PSPB COA PROPOSAL - CORRECTIONS

# GRAND CENTRAL BLOCK

200 S 1ST ST, Seattle, WA 98104

# ROOF PLAN

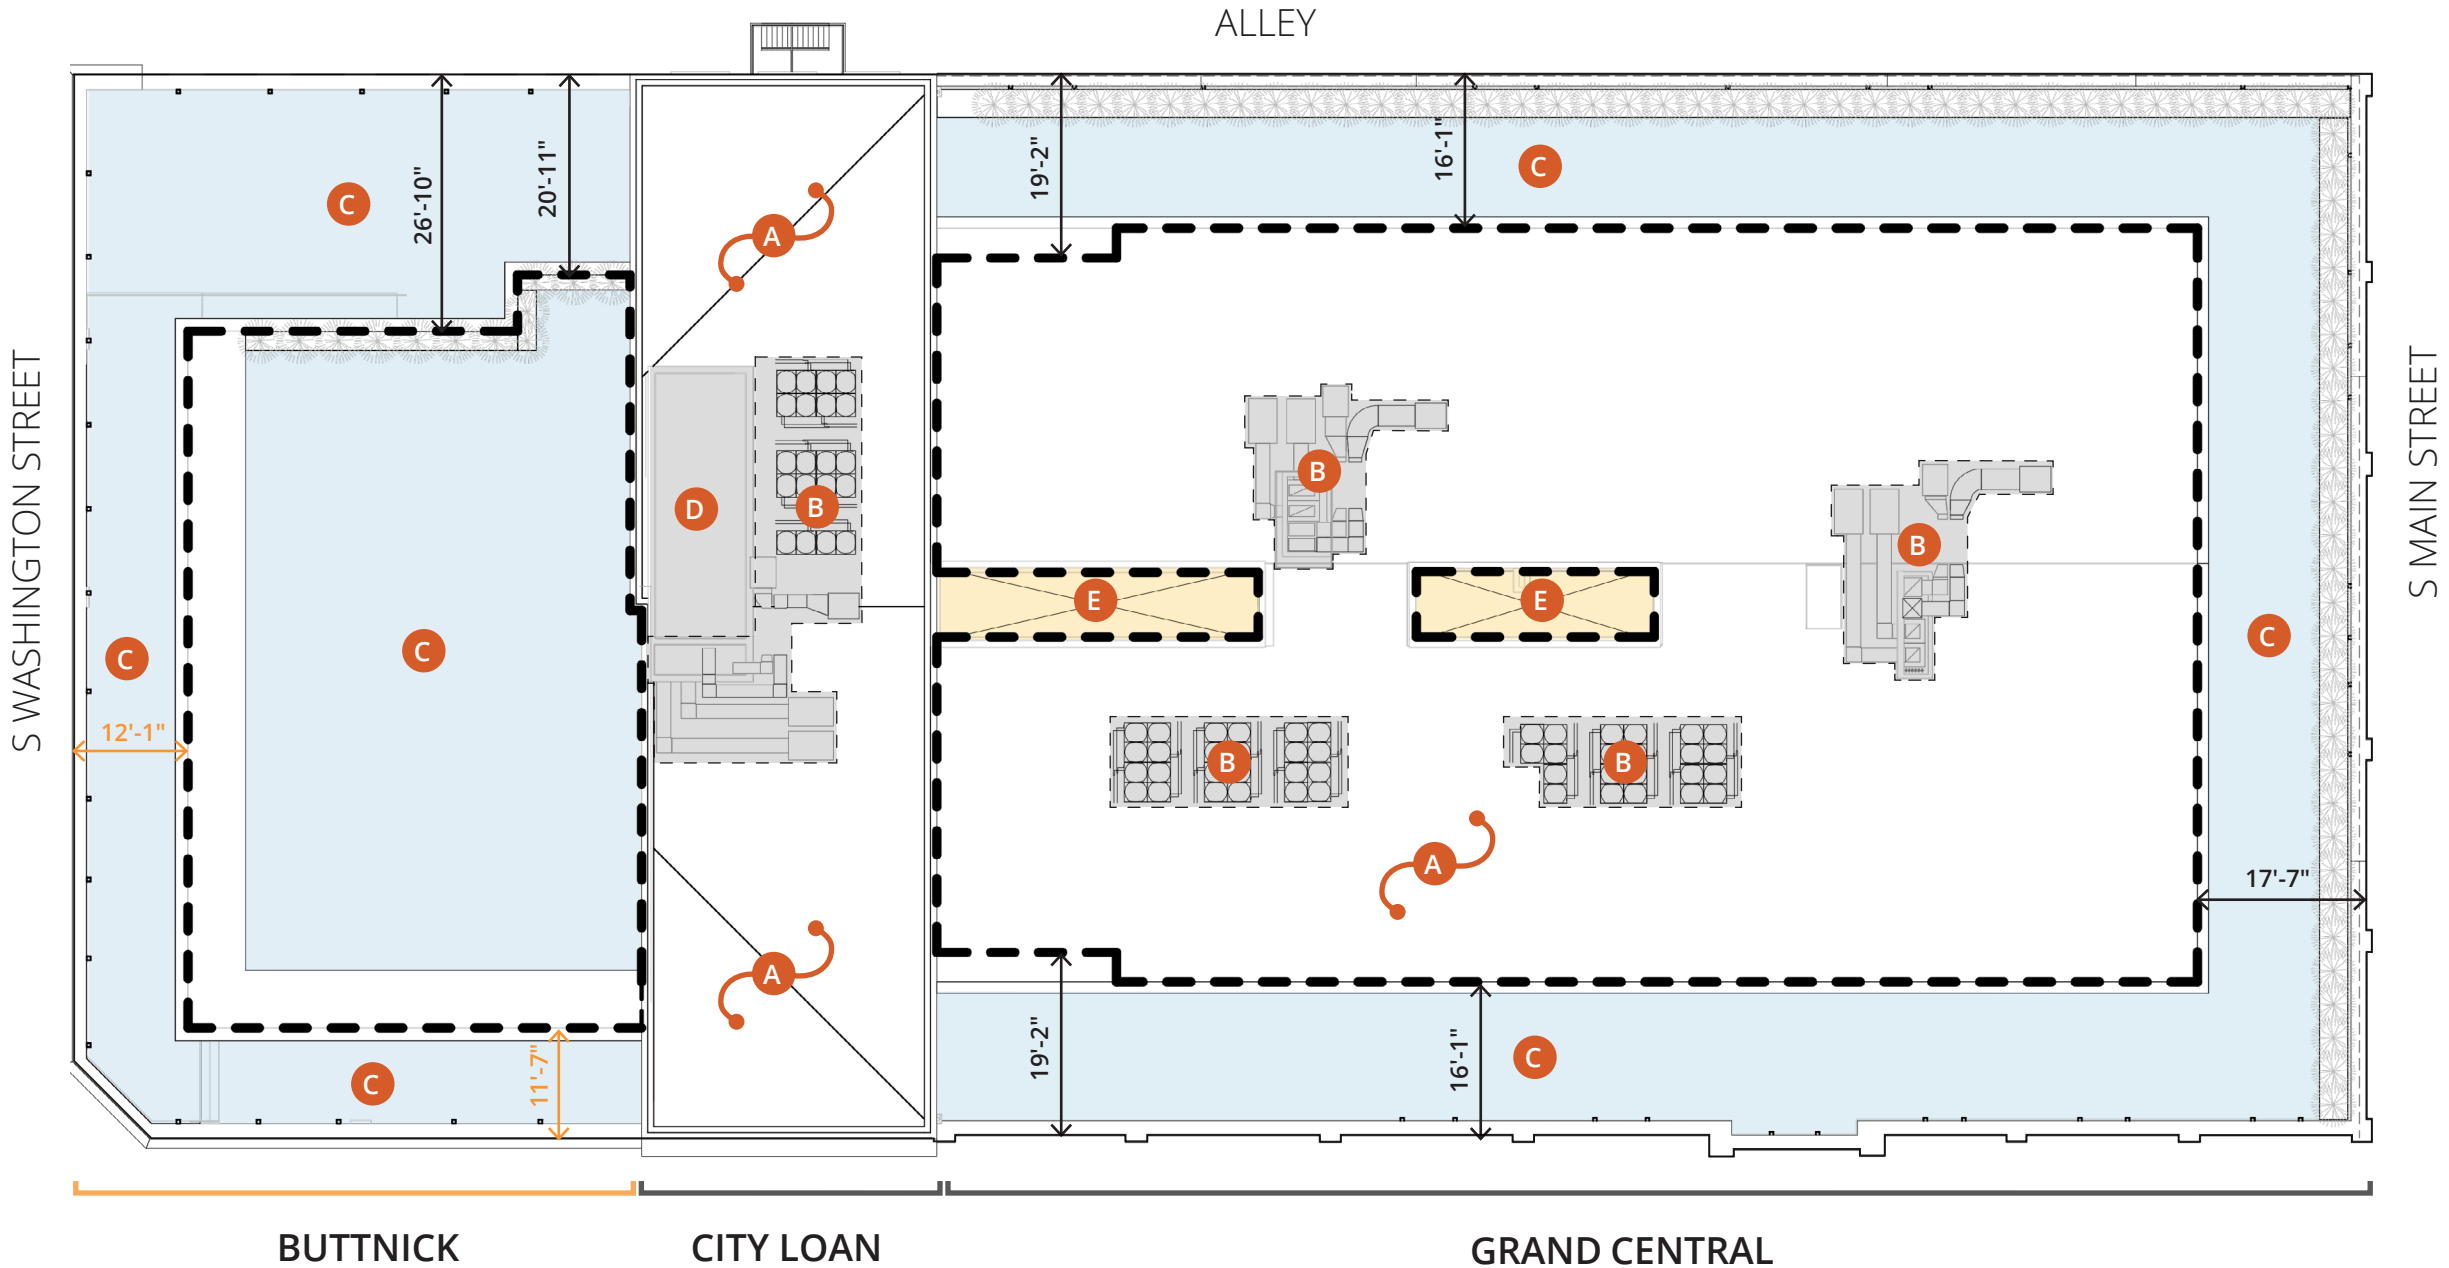
The plans stated that the coverage is 53% which is over the 50% allowed in the code for use as an office or residential penthouse. SMC 23.41.012 lists measurements and maximum size of use as items that are not departable. (Staff Report 8/5/2020)

The penthouse has been reduced to 50% roof coverage.

# BUTTNICK PENTHOUSE - VIEW STUDY

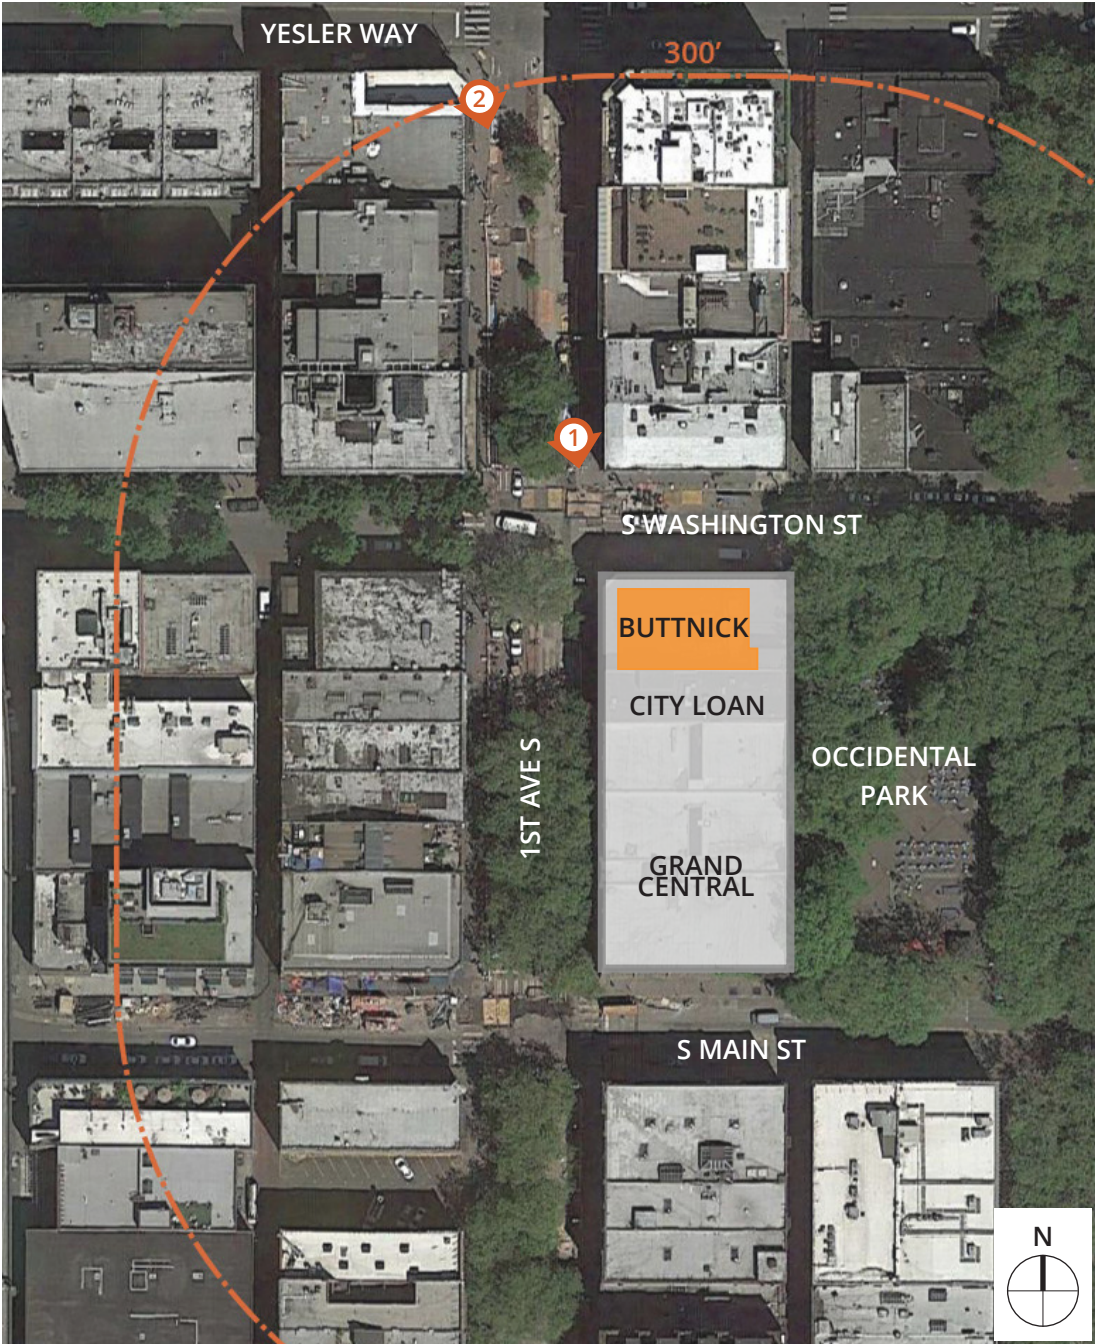
The Board would first have to determine if the penthouse is minimally visible from 300 feet. It appears visible in what is provided. (Staff Report 8/5/2020)

Photos are from the penthouse mockup performed in March 2021. The penthouse height and footprint shown are a reduction compared to the previous Board Briefing.

# BUTTNICK PENTHOUSE - VIEW STUDY

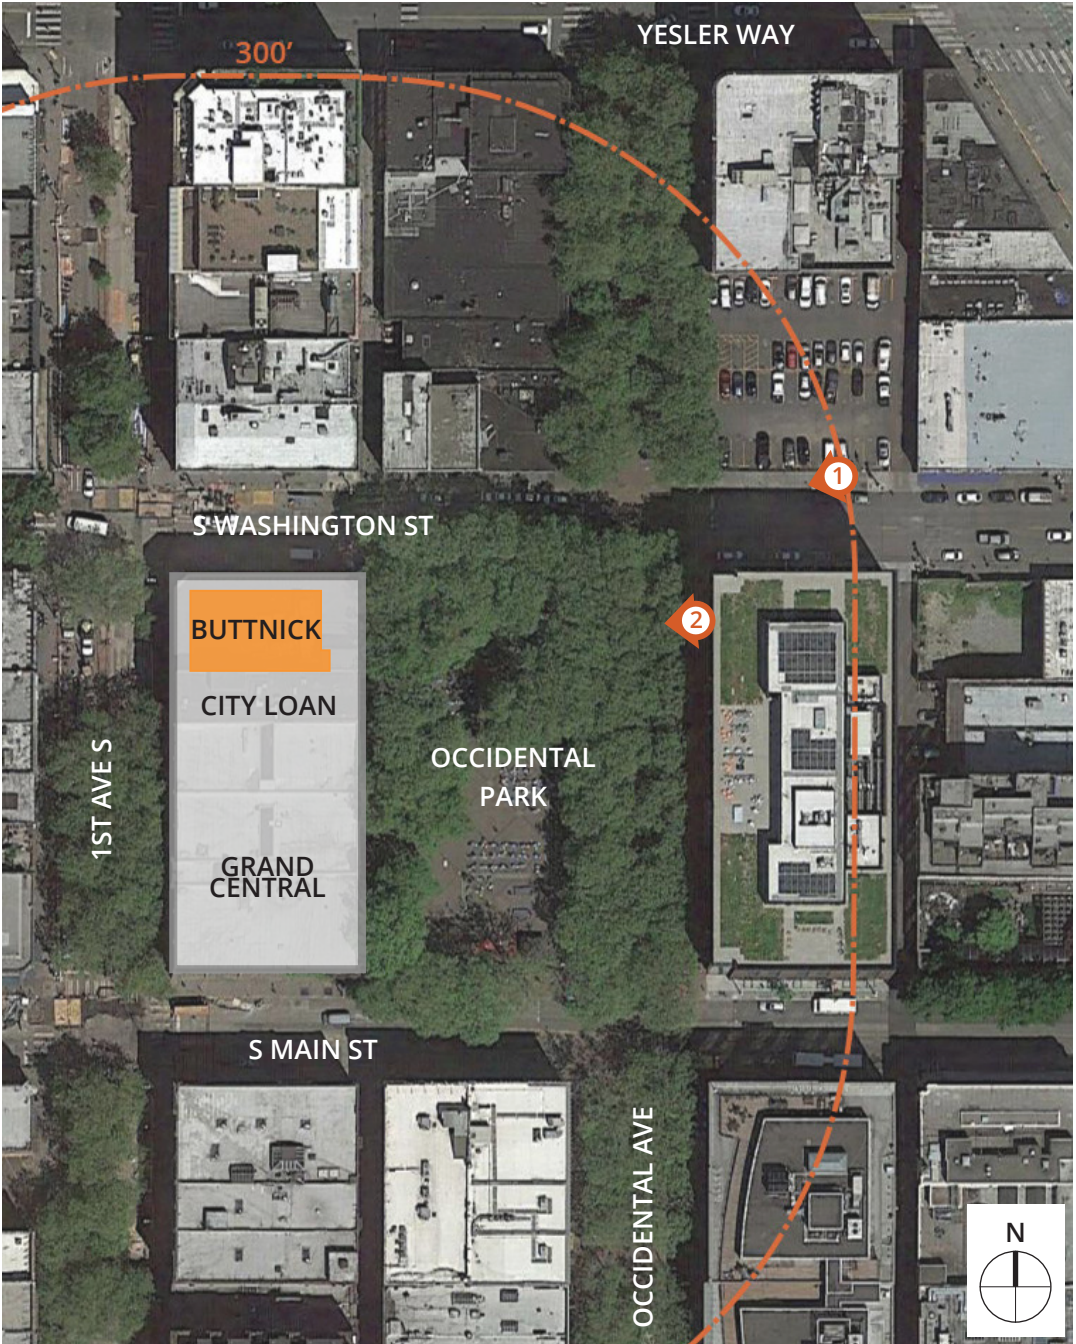
The Board would first have to determine if the penthouse is minimally visible from 300 feet. It appears visible in what is provided. (Staff Report 8/5/2020)

Photos are from the penthouse mockup performed in March 2021. The penthouse height and footprint shown are a reduction compared to the previous Board Briefing.

# GRAND CENTRAL PENTHOUSE - VIEW STUDY

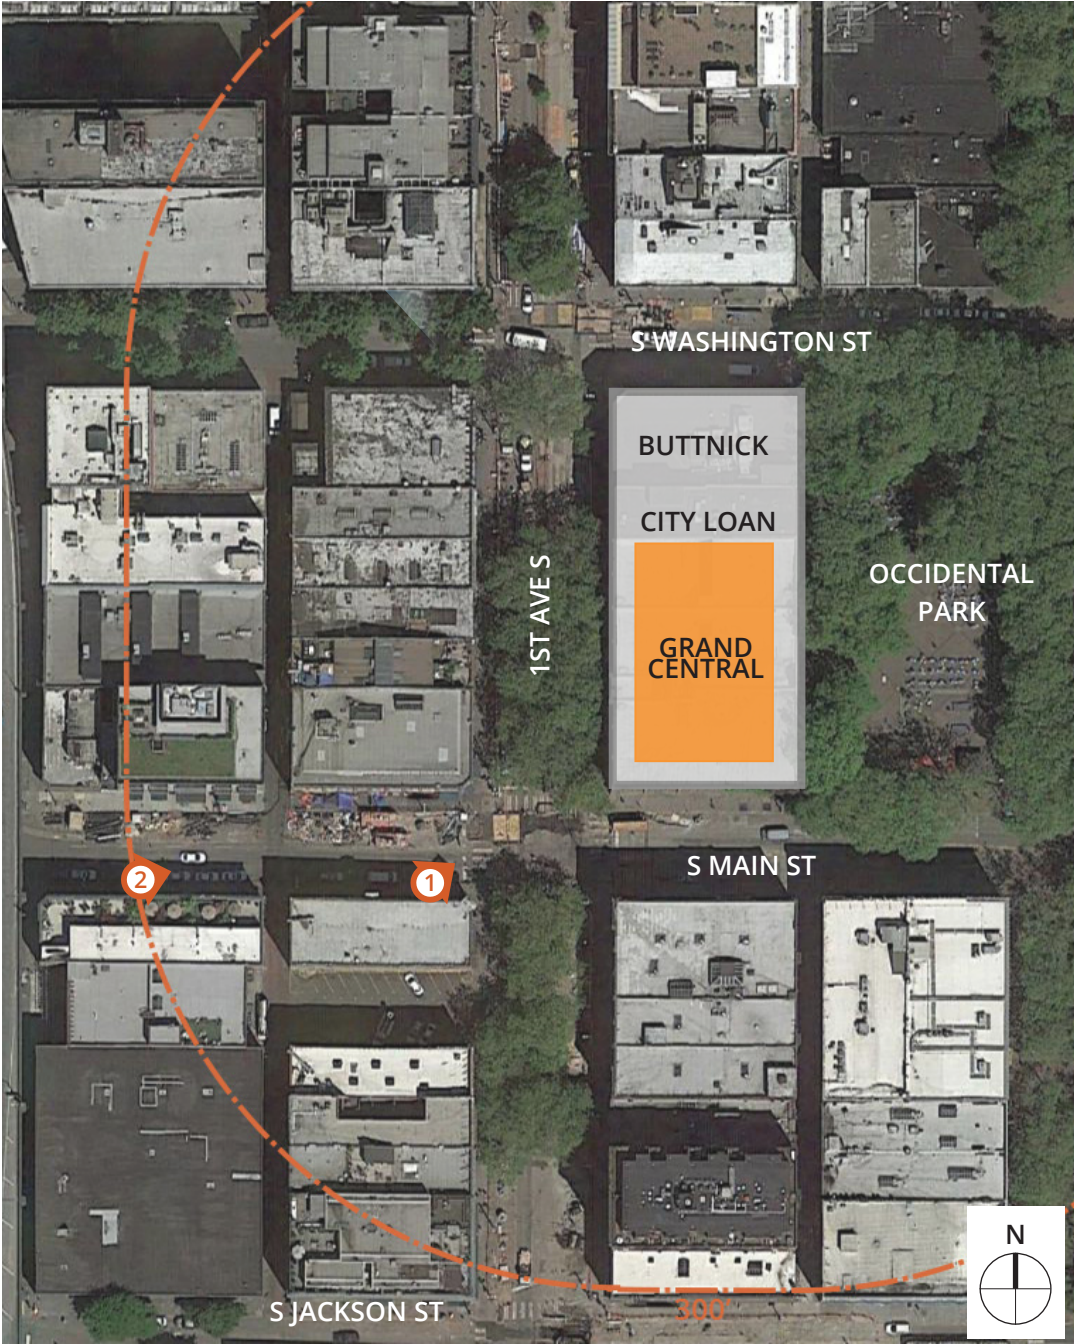
The Board would first have to determine if the penthouse is minimally visible from 300 feet. It appears visible in what is provided. (Staff Report 8/5/2020)

Photos are from the penthouse mockup performed in March 2021. The penthouse height and footprint shown are a reduction compared to the previous Board Briefing.

# GRAND CENTRAL PENTHOUSE - VIEW STUDY

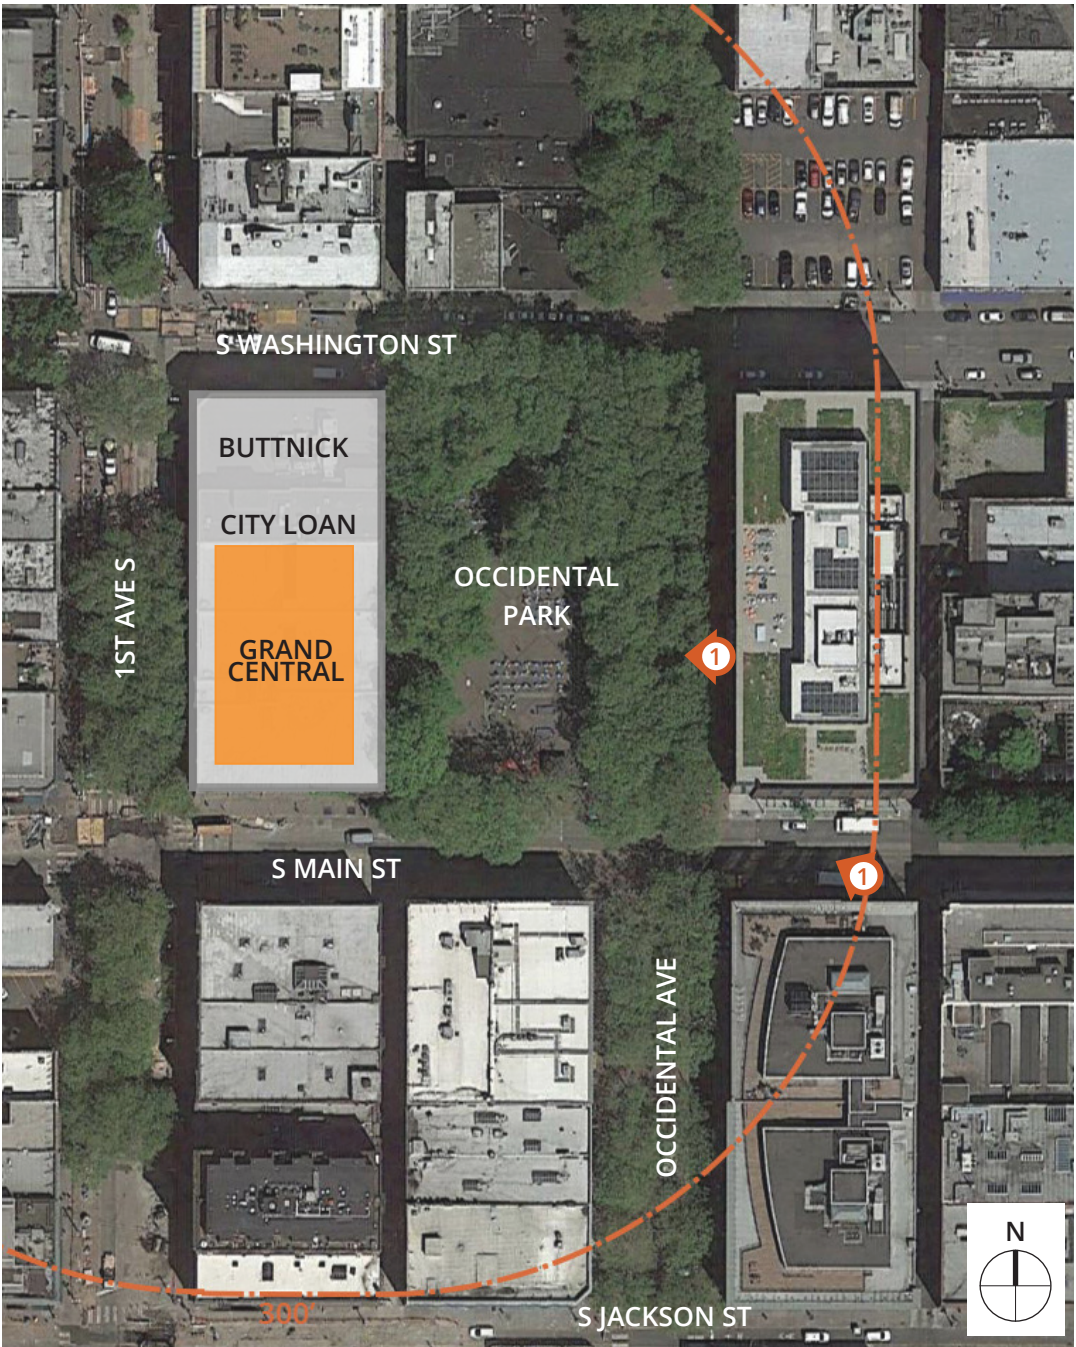
The Board would first have to determine if the penthouse is minimally visible from 300 feet. It appears visible in what is provided. (Staff Report 8/5/2020)

Photos are from the penthouse mockup performed in March 2021. The penthouse height and footprint shown are a reduction compared to the previous Board Briefing.
